Info Only: Engineering comments
are in blue text.

FINAL DRAINAGE REPORT
for
OWL MARKETPLACE FILNG NO. 1
PRE-SUBDIVISION GRADING

El Paso County File No. VR2321

Please update to
CDR247

PROJECT INFORMATION

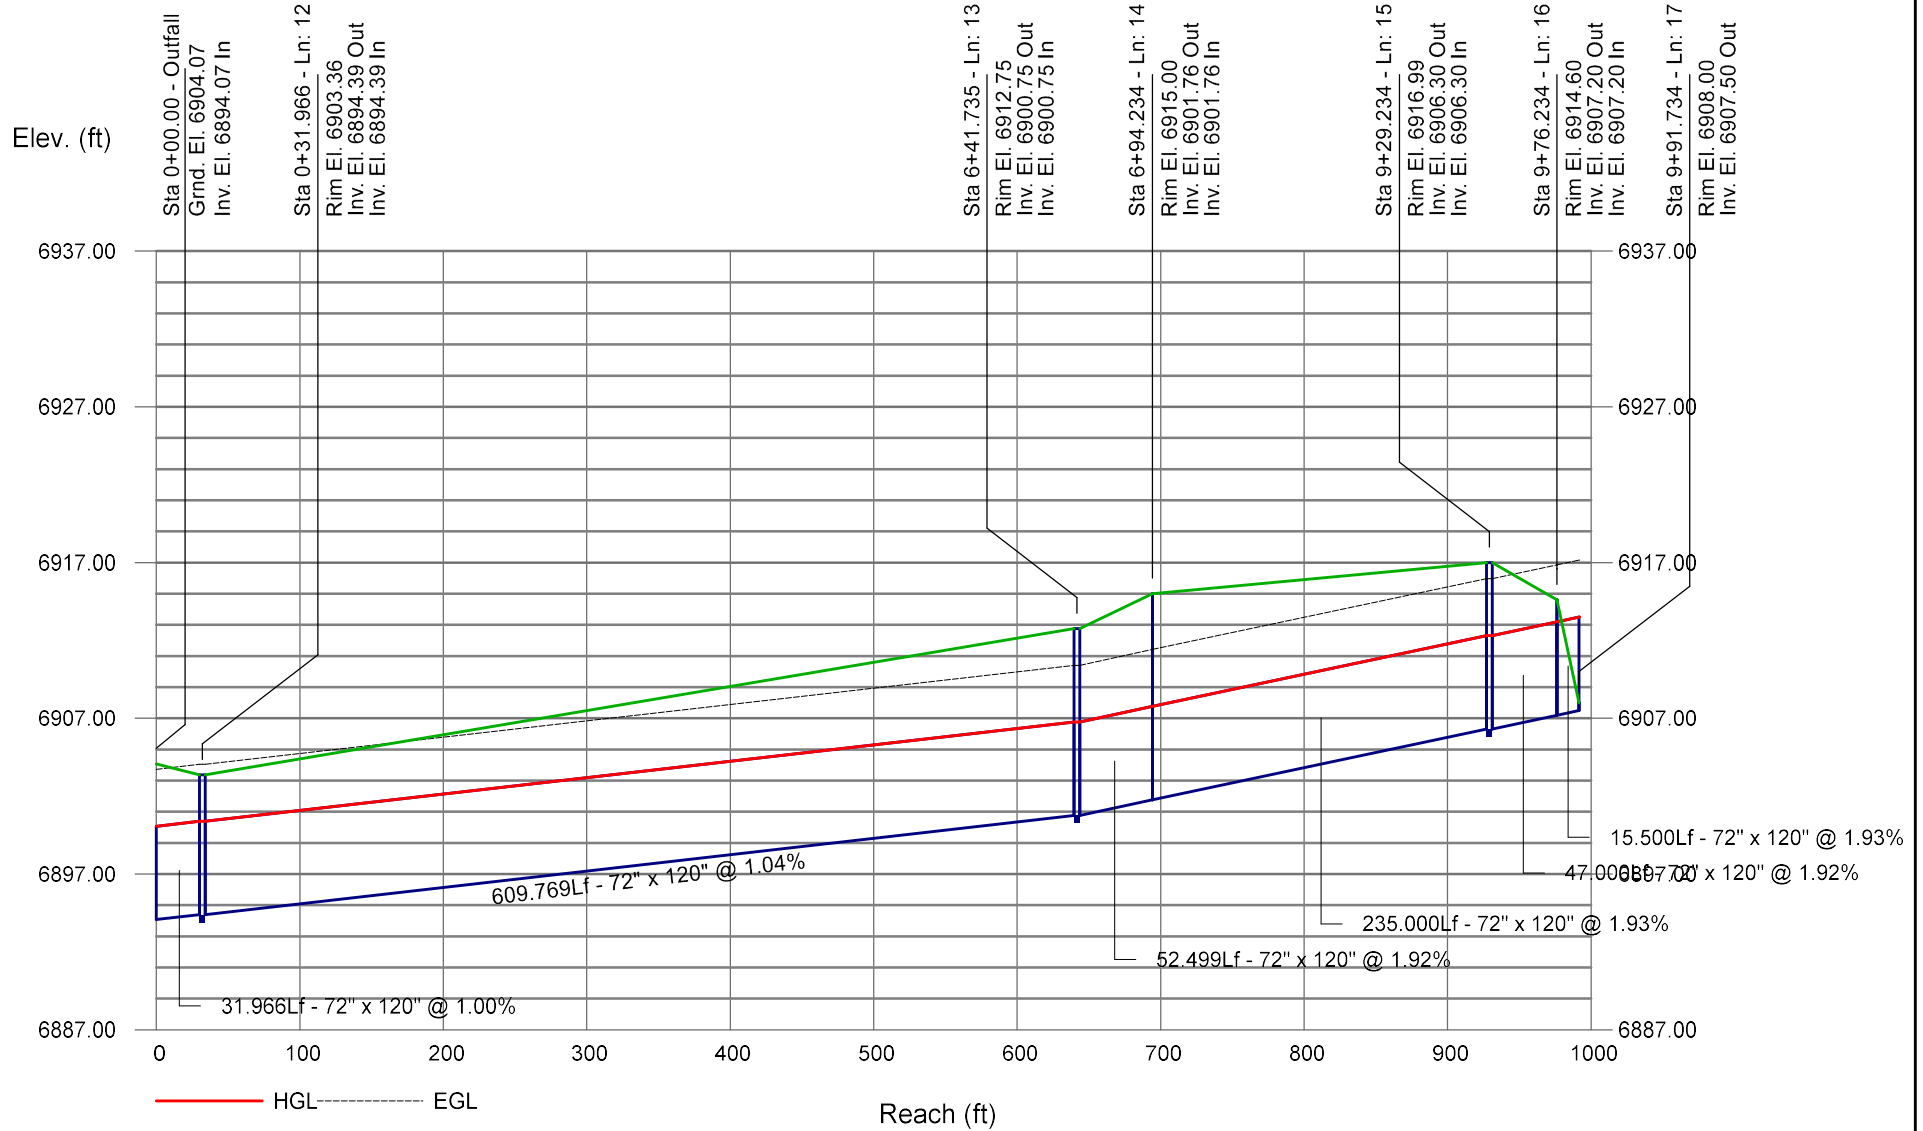
The velocity shall not fall below the minimum requirement of 4 ft/s or a minimum slope of 0.5%. Please adjust the VR2321 accordingly.

EXISTING DRAINAGE MAP
 PROJECT NO. 21611-01CSCV
 DRAWING NO.

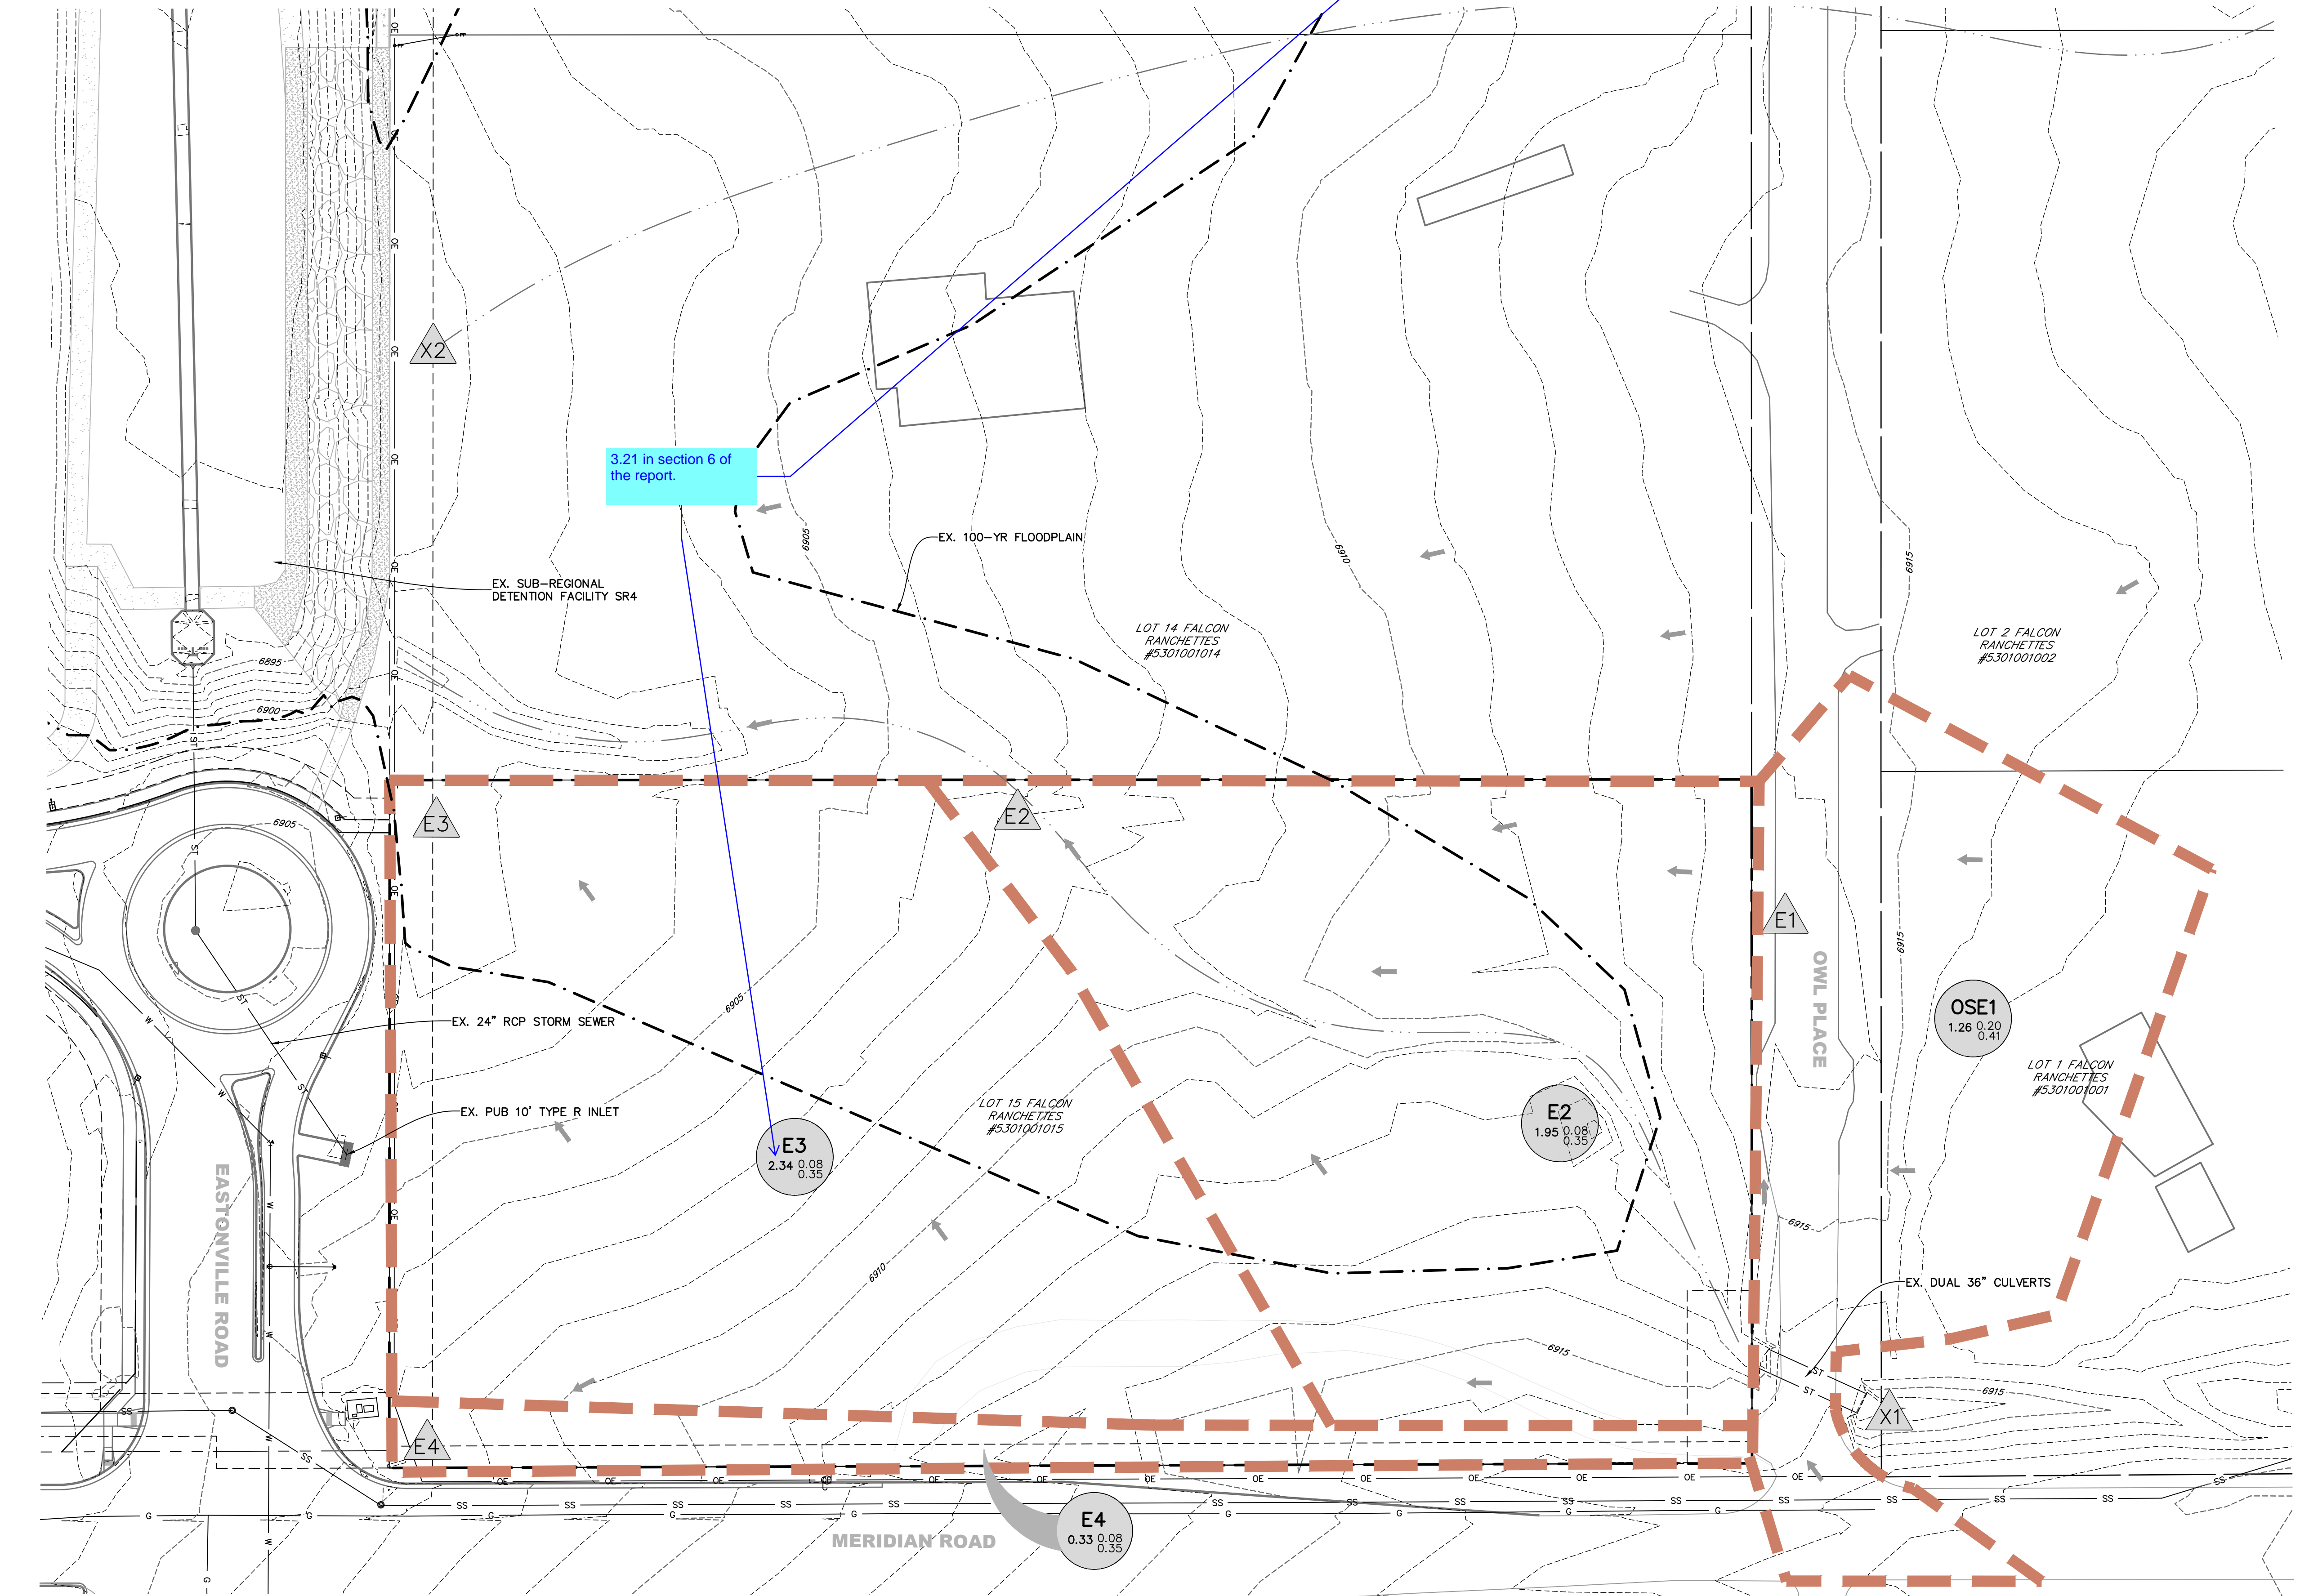
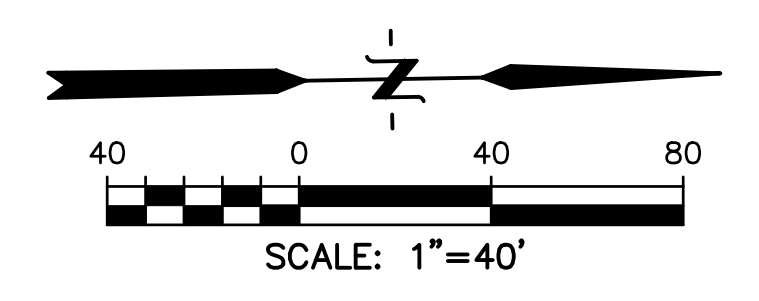
3.21 in section 6 of the report.
